Proposal Request

PROJECT: *(name and address)*
AWSOM
Bentonville, Arkansas

PROPOSAL REQUEST 105

RFI #553 Data Room Equipment Racks

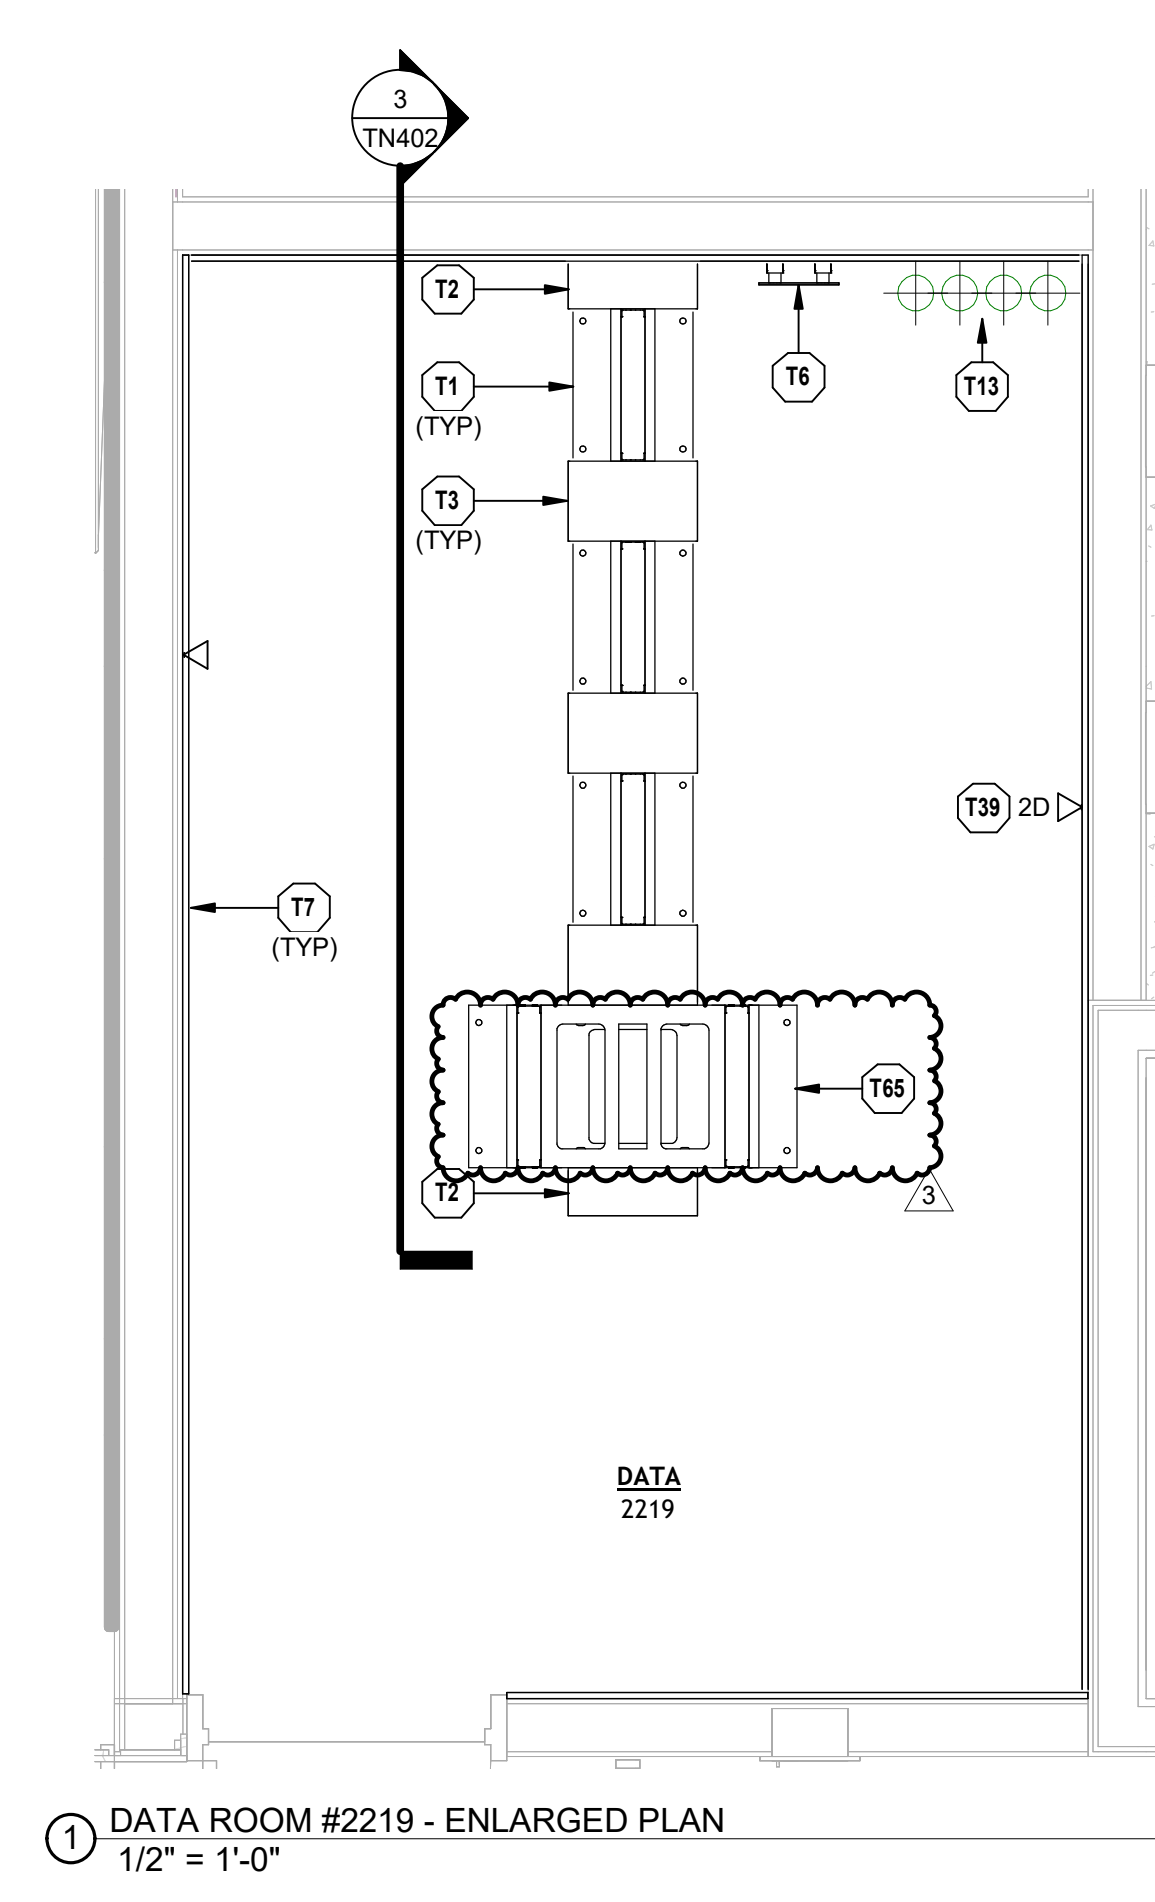
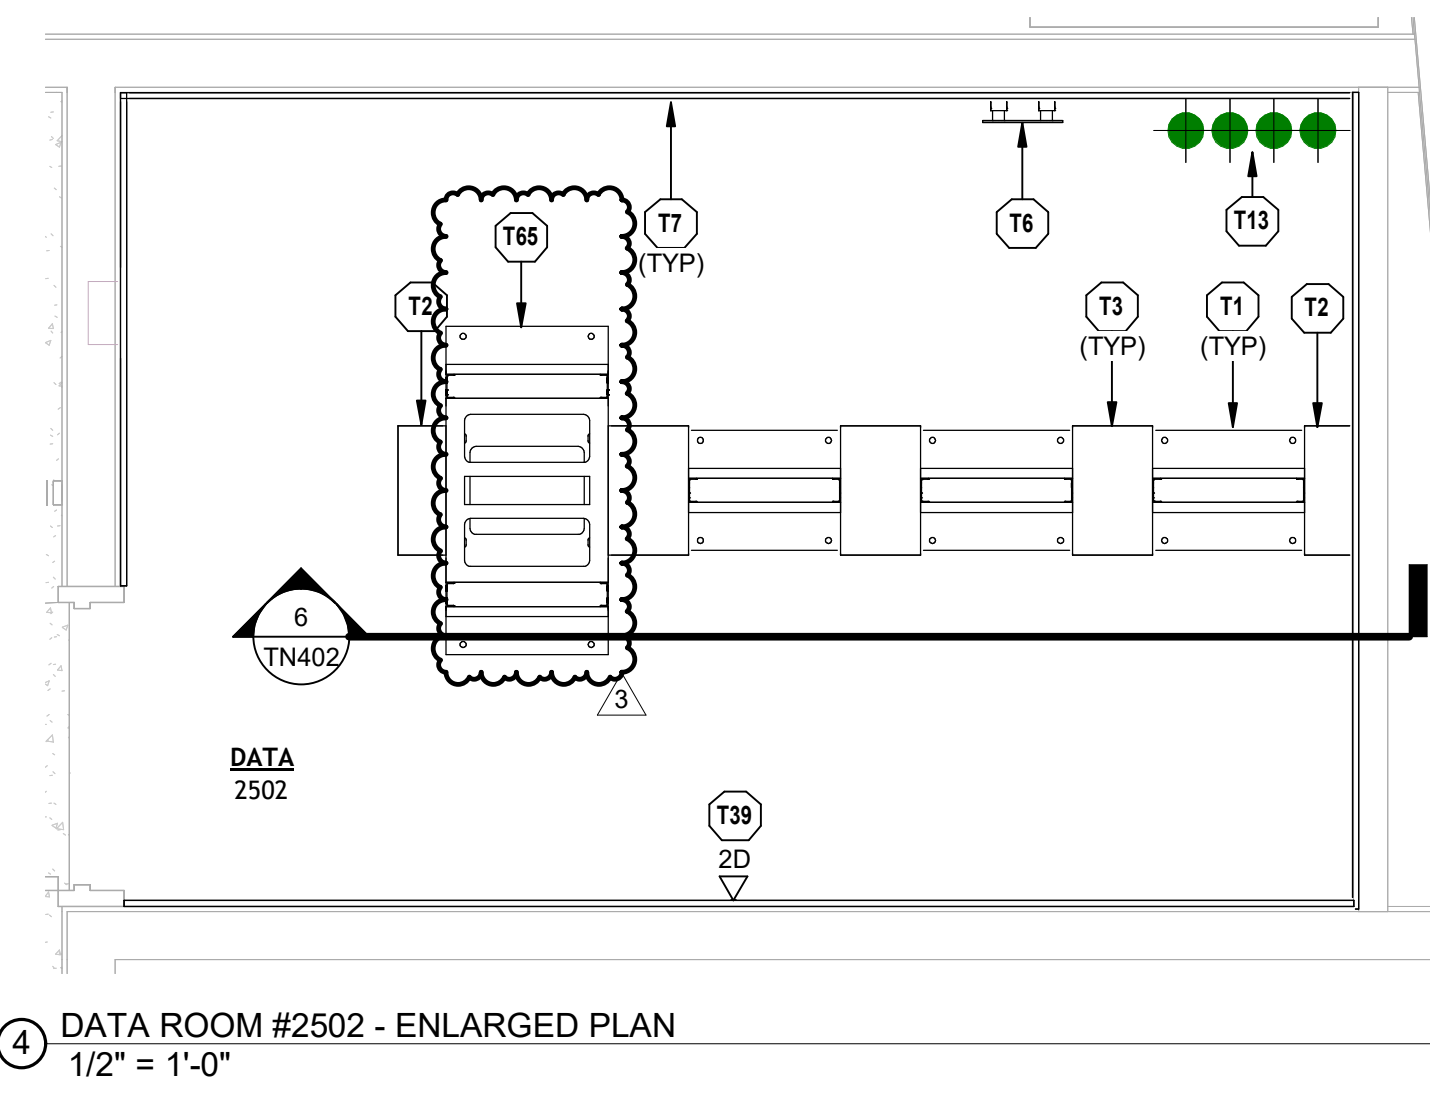
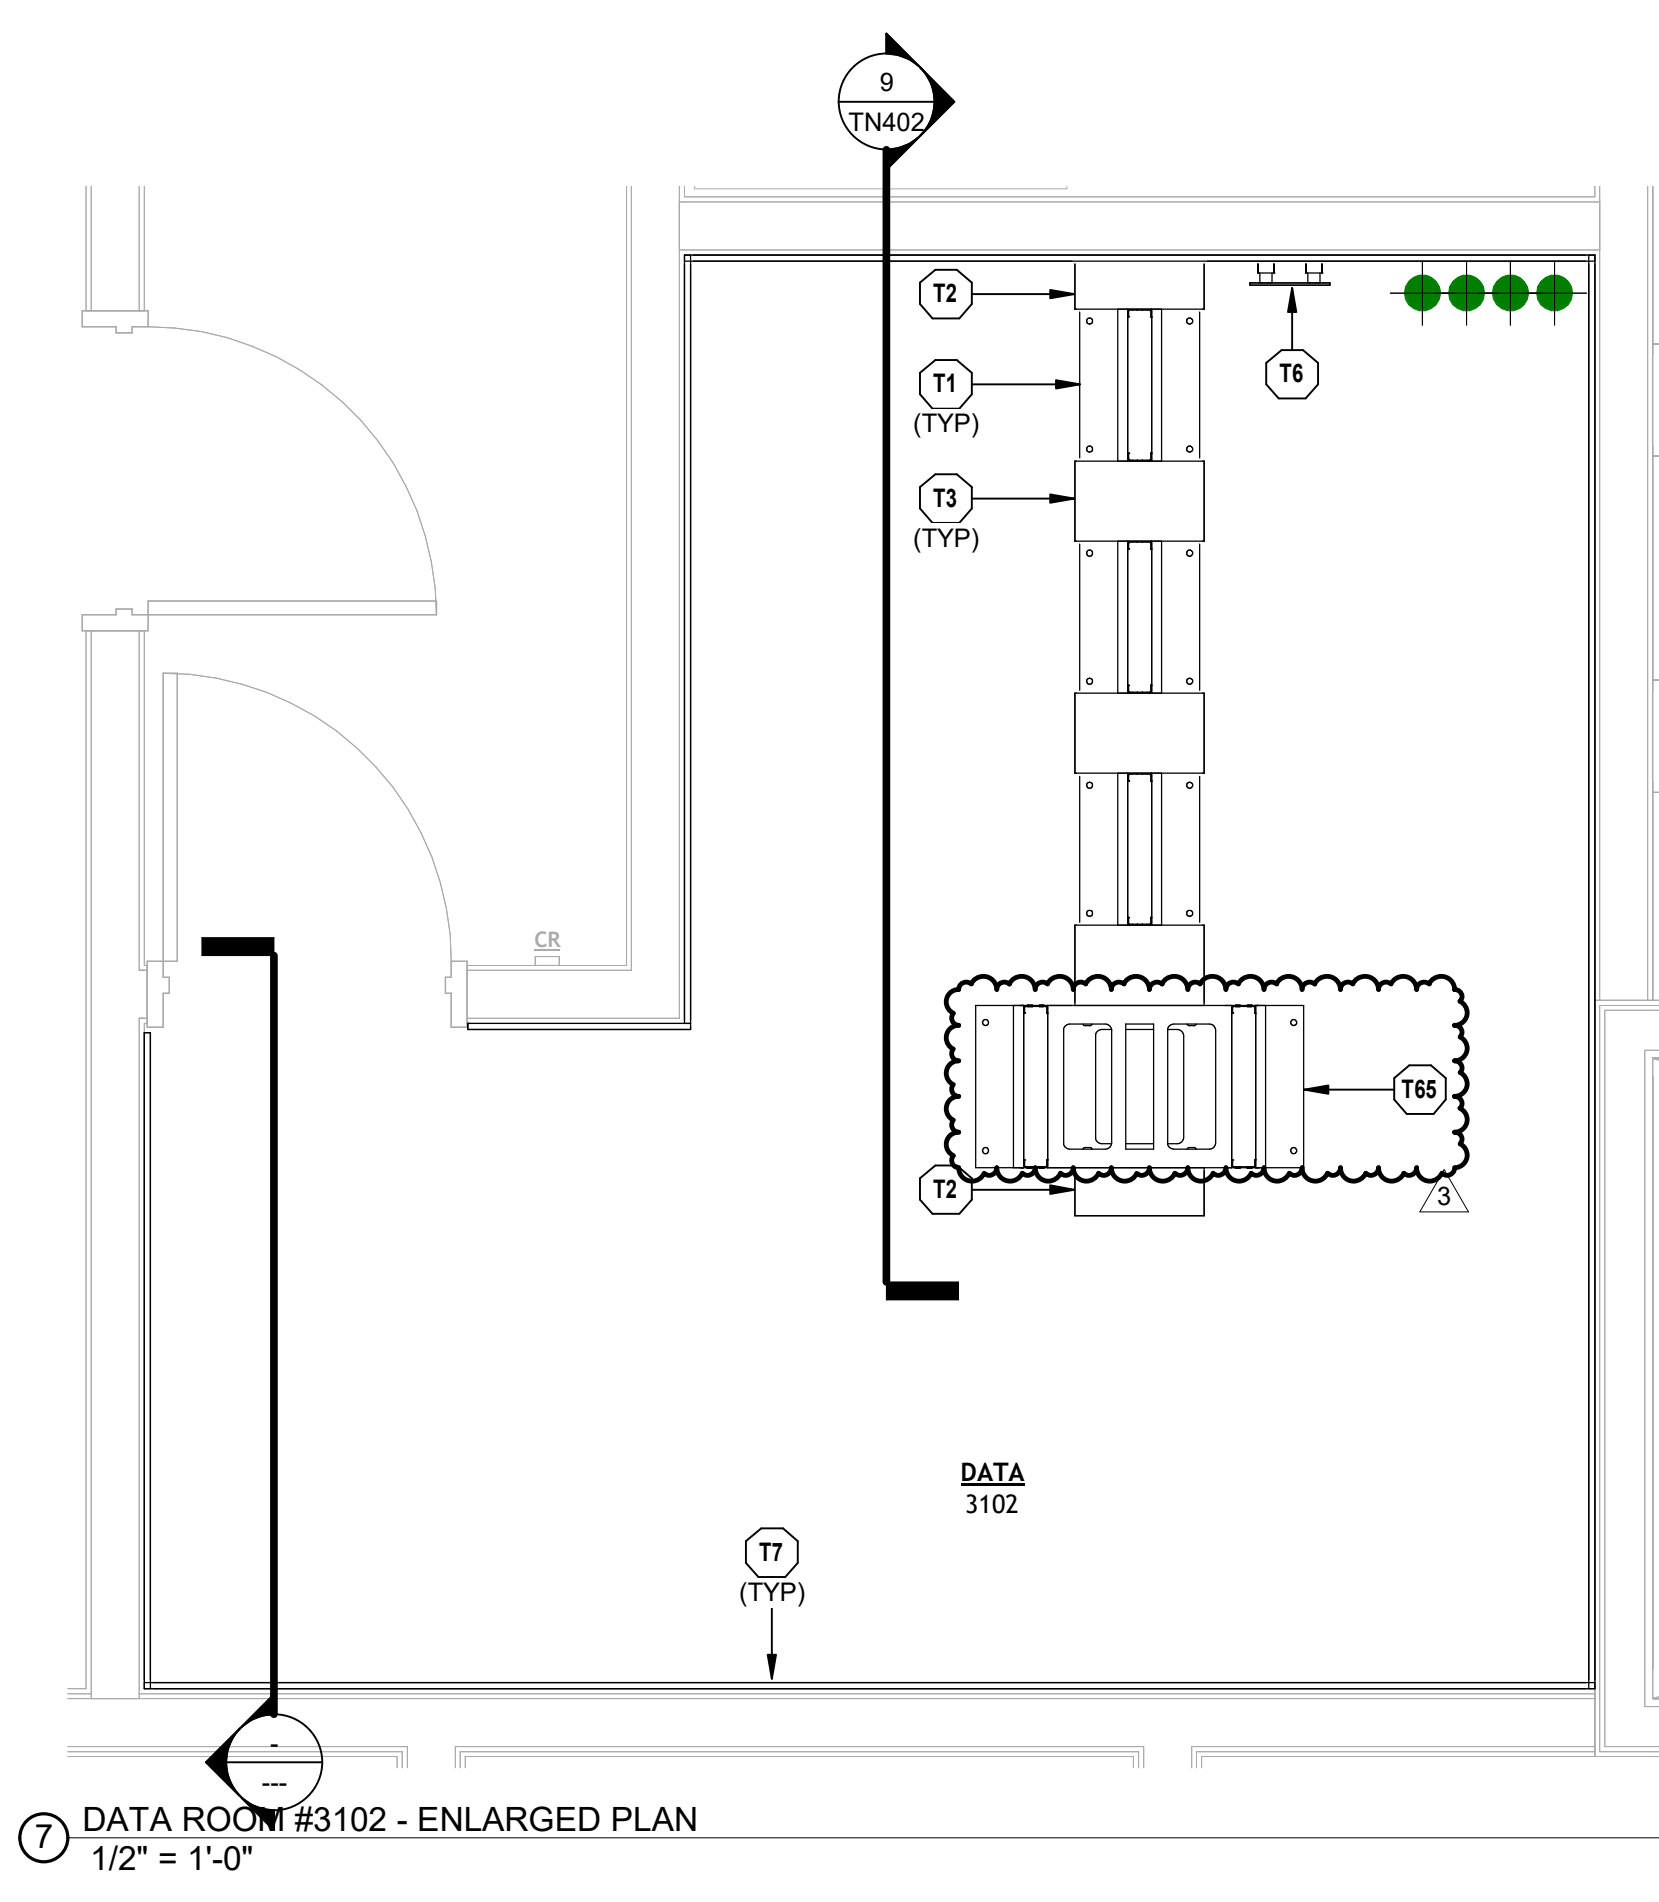
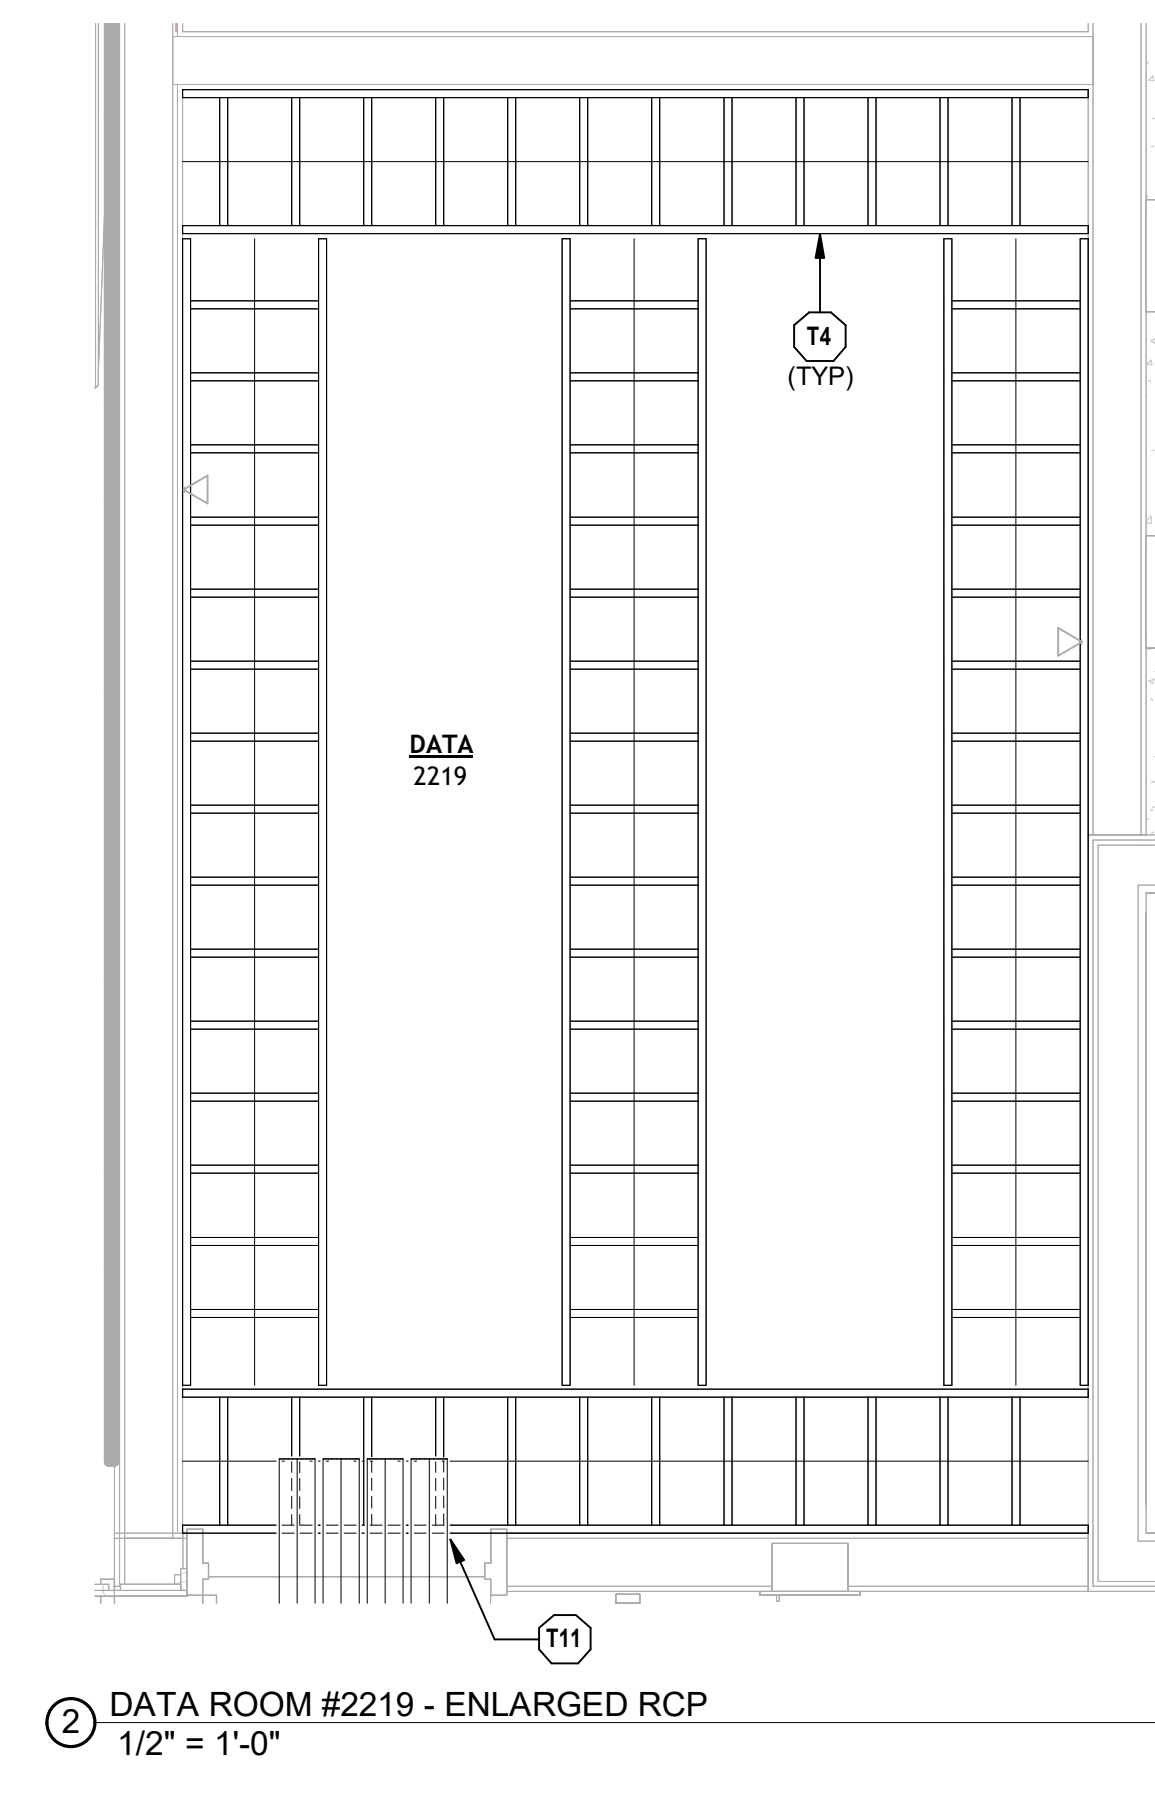
- a) Revised Sheet **TN401**
 - Added keynote T65.
 - Changed (1) 2-post rack in each telecom room to a 4-post rack.
(1) Applies to Rooms 0120, 1204, 1538, and 1622.
- b) Revised Sheet **TN402**
 - Added keynote T65.
 - Changed (1) 2-post rack in each telecom room to a 4-post rack.
(1) Applies to Rooms 2219, 2502, and 3102.
 - Detail 8 – Added keynote T11 pointing to already present conduit sleeves.
- c) Revised Sheet **TN403**
 - Added keynote T65.
 - Changed (1) 2-post rack in each telecom room to a 4-post rack.
(1) Applies to Rooms 3316, 3504, and 4104.
 - Detail 2 – Added keynote T11 pointing to already present conduit sleeves.
 - Detail 8 – Added keynote T11 pointing to already present conduit sleeves.

105 PROVIDE FOUR-POST FLOOR RACK. SEE DIVISION 27 SPECIFICATIONS FOR ADDITIONAL INFORMATION.
